JOB# J-045679

SCN RESOLUTION & PHOTO

Pole Number (Old Pole and New Pole, If Available)	Latitude/Longitude or Address	Noticing Company	Date Completed	Completed By
644931E	34.41174977 -119.86379973	HHS	11/14/2023	HAYDEN PRUDHOMME

Pole Number (Old Pole and New Pole, If Available)	Latitude/Longitude or Address	Noticing Company	Date Completed	Completed By
644939E	34.413818 -119.862661	HHS	11/14/2023	HAYDEN PRUDHOMME

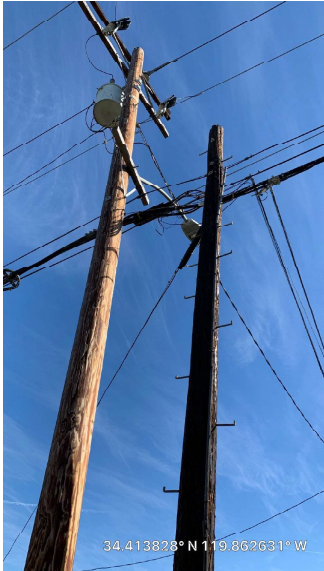
Crown Castle needs to transfer its facilities from the buddy pole to the new pole.
CAMINO DEL SUR W/S 1271' S/O COLEGIO RD

Removed Guard Arm and Replaced with F-Arm
Placed Fiber Tag
Trimmed Tree 65'

Pole Number (Old Pole and New Pole, If Available)	Latitude/Longitude or Address	Noticing Company	Date Completed	Completed By
1081714E	34.451635 -119.758051	HHS	11/15/2023	HAYDEN PRUDHOMME

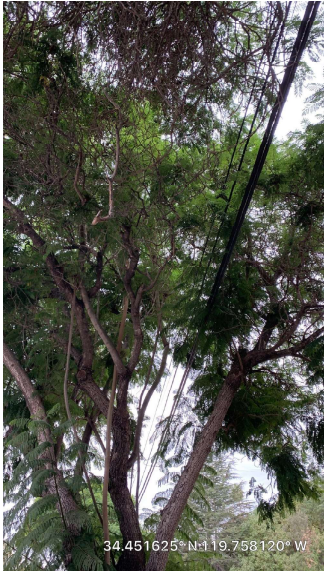
Crown Castle communications conductor supported on Pole number 1081714E was touching a third-party communication down guy wire
1061 Foothill Rd Santa Barbara, Ca 93110

Placed Box Guard
Trimmed Tree 100'

Pole Number (Old Pole and New Pole, If Available)	Latitude/Longitude or Address	Noticing Company	Date Completed	Completed By
1188675E	34.41174661 -119.864222	HHS	11/14/2023	HAYDEN PRUDHOMME

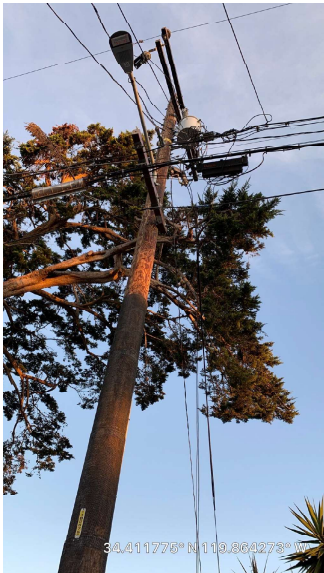
Crown Castle communications conductor was touching a third-party communications service drop.
PASADA RD N/S 470' W/O CAMINO DEL SUR

Fixed Box Guard and Spec Hardware
Re-tension span
Removed Drops from Lead and Placed Fiber Tag

Before Photo #1

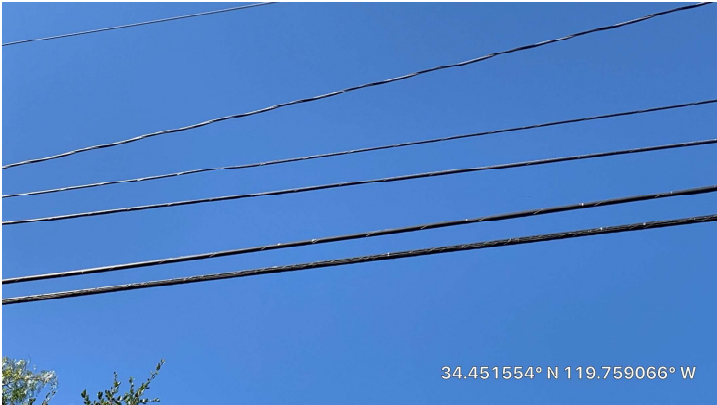
Crown Castle communications conductor had less than 12 inches of vertical separation from a third-party communications conductor.

Placed Snow Show
Trimmed Tree Approx 20'
Placed Fiber Tag

Before Photo #2 (If Necessary)

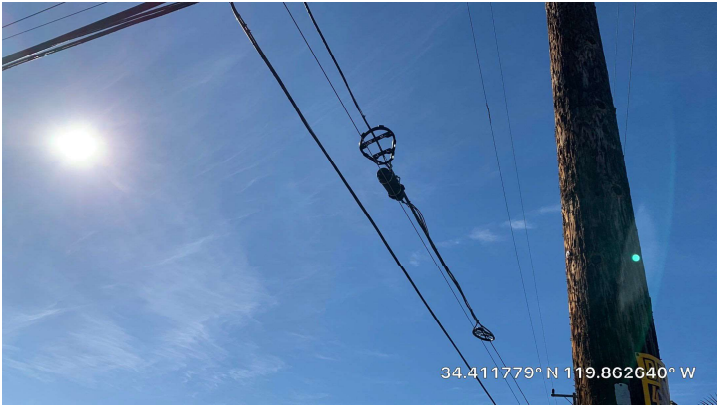
A Crown Castle splice box was loose and not secured to the pole.
CAMINO DEL SUR N/W COR/O PASADO RD

Re-Secure Splice Case
Placed Snow Shoe

Pole Number (Old Pole and New Pole, If Available)	Latitude/Longitude or Address	Noticing Company	Date Completed	Completed By
S29049Y	34.41339167 -119.86261666	HHS	11/14/2023	HAYDEN PRUDHOMME

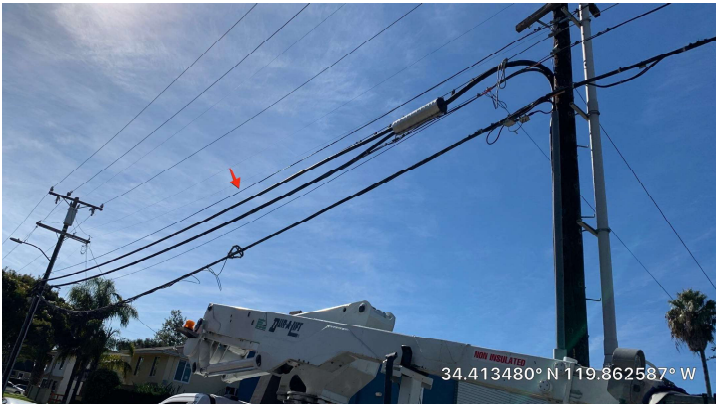
a Crown Castle communications conductor was touching a third-party communications conductor.
CAMINO DEL SUR W/S 266' S/O ABREGO RD

Spec Hardware
Placed Fiber Tag
Re tensioned Span
